SUBJECT: North Shore Connector
NSC Train Systems (System Wide)
Contract No. NSC-009

DATE: July 31, 2008

Port Authority of Allegheny County

Contract No. NSC-009

**NORTH SIDE STATION GENERAL PLAN**

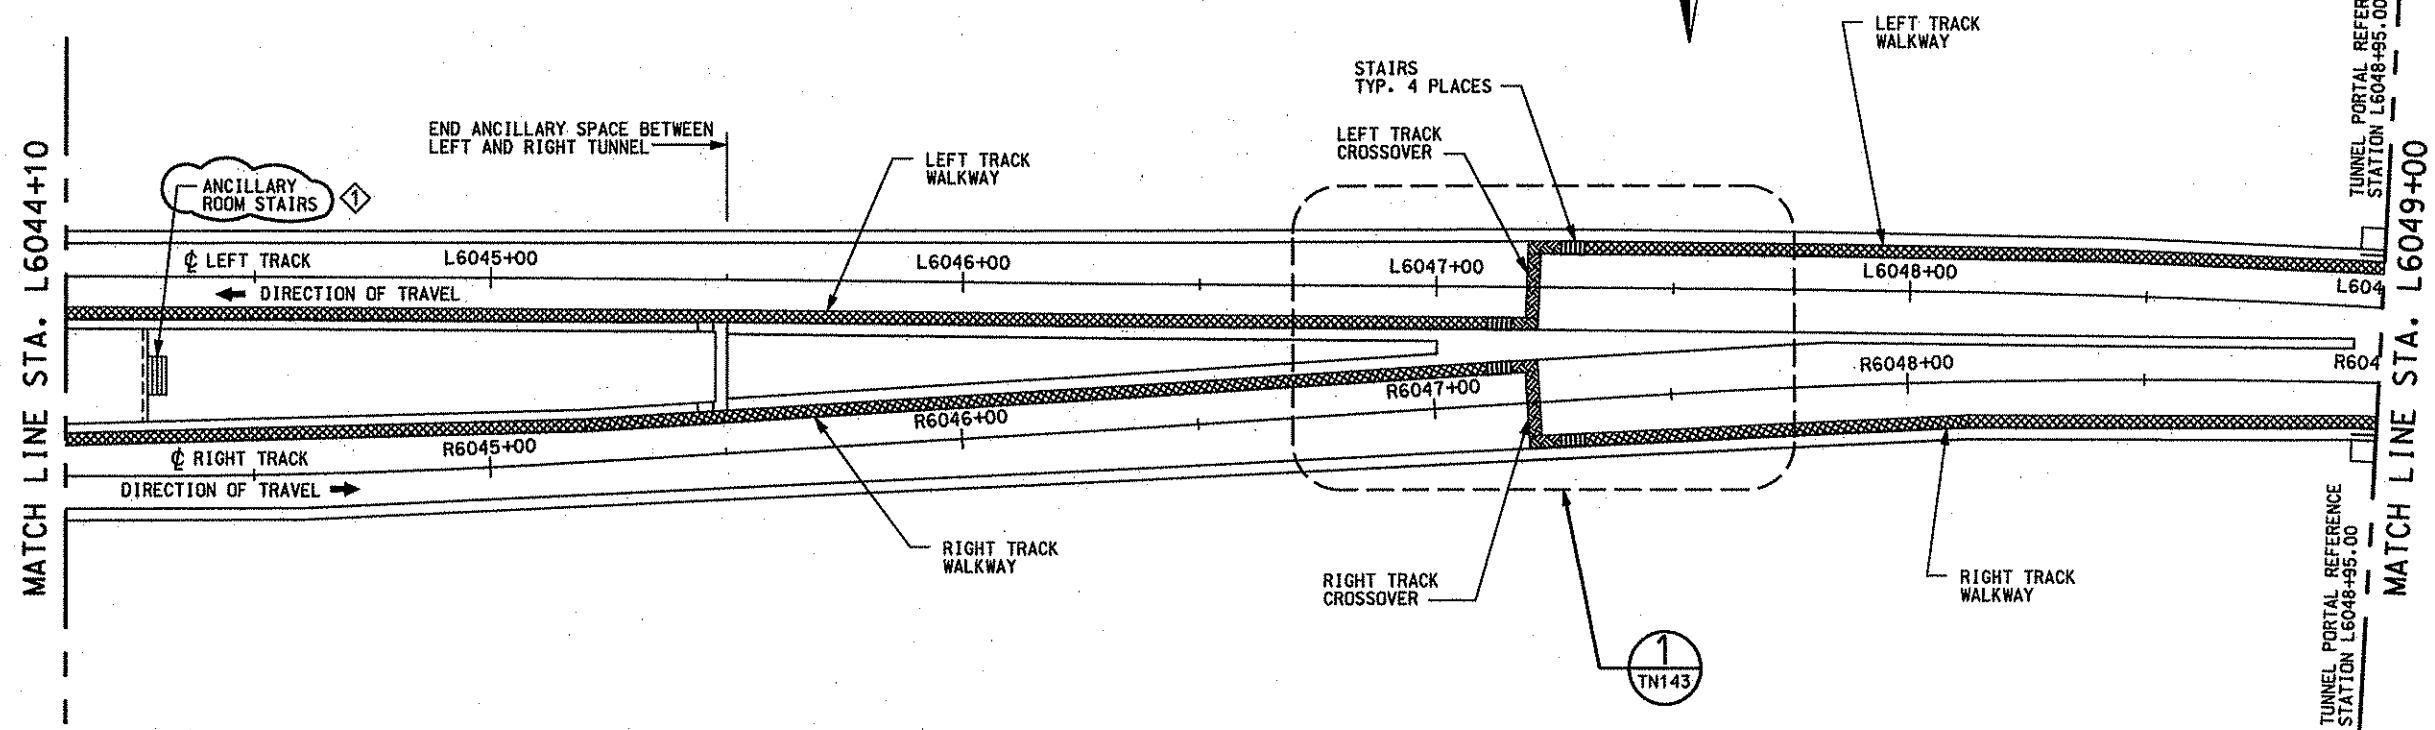
1. Drawing No. TN130, Sheet No. 54. Drawing Modified.
2. Drawing No. TN137, Sheet No. 61. Drawing Modified.
3. Drawing No. CV113, Sheet No. 92. Drawing Modified.
4. Drawing No. SG019, Sheet No. 345. Drawing Modified.
5. Drawing No. SG184, Sheet No. 422. Drawing Modified.
6. Drawing No. CR100, Sheet No. 563. Drawing Modified.
7. Drawing No. CR101, Sheet No. 564. Drawing Modified.
8. Drawing No. CR104, Sheet No. 567. Drawing Modified.
9. Drawing No. CR105, Sheet No. 568. Drawing Modified.
